COUNCIL ASSESSMENT REPORT

Panel Reference	2016SYE005
DA Number	DA-2016/241
LGA	BAYSIDE
Proposed Development	Demolition of existing structures and construction of 1 x 11 storey apartment building and 2 x 10 storey mixed use buildings over 3-6 levels of basement parking (580 parking spaces), with rooftop communal space, public domain/landscape works in Chapel Street and Chapel Lane, reconstruction and widening of Chapel Lane and stratum subdivision.
Street Address	Nos. 1-11 Chapel Street, Nos. 1-3 Chapel Lane and Nos. 6A-12 Lister Avenue, and portions of Chapel Street and Chapel Lane ROCKDALE NSW 2216
Applicant/Owner	Applicant: Combined Projects (Rockdale) Pty Ltd Owner: Combined Projects (Kogarah) Pty Ltd, Combined Projects (Rockdale) Pty Ltd, Rockdale Council
Number of Submissions	Twelve(12)
Regional Development Criteria (Schedule 4A of the Act)	Cost of proposal \$129,928,125
List of all relevant s79C(1)(a) matters	<ul style="list-style-type: none"> • SEPP (Infrastructure) • SEPP (BASIX) • SEPP 55 • SEPP 65 • Apartment Design Guide • SREP No. 2 • Rockdale LEP 2011 • Rockdale DCP 2011

Precis

Height map of subject site

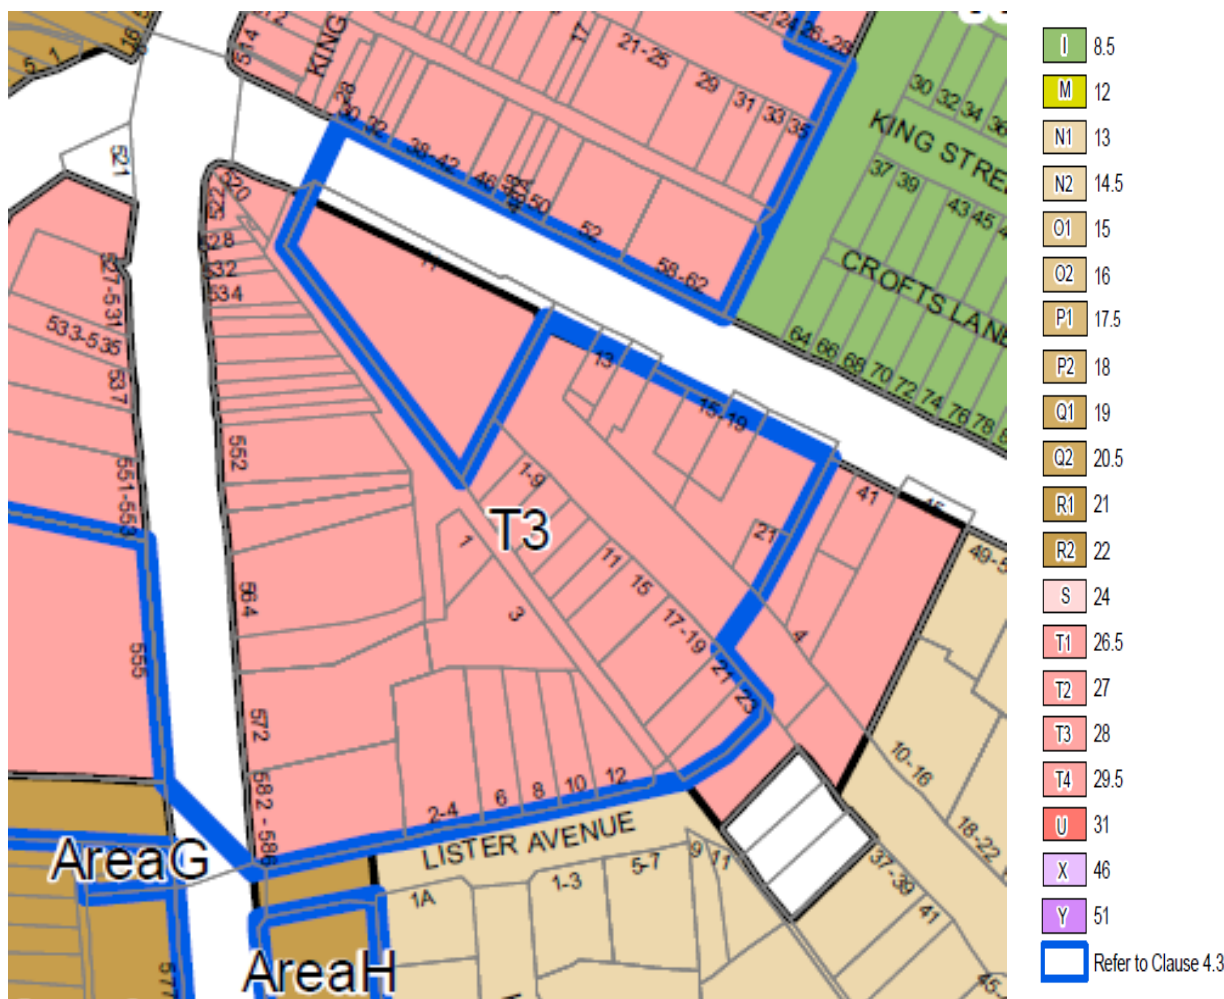
Sites A and C have a site areas of 3,315m² and 2,960m², and as such, subject to compliance with clause 6.14, a 40m height control applies. Site B has a site area of 1,496m² and as such fails to satisfy the 1,500m² site area criteria to permit a 40m height limit. In this regard the applicant relies upon the proposed stratum of land below ground level under Chapel Lane (site area approximately 324m²), to increase the size of Site B to be compliant with the minimum 1,500m² site area criteria for clause 4.3(2A).

However, the works within that area provide for parking for both Sites A and B and as such if this area were to be included for the purpose of this provision, a combined area for Sites A, B and the portion of Chapel Lane would need to be considered, the combined of which would be approximately 5,135m².
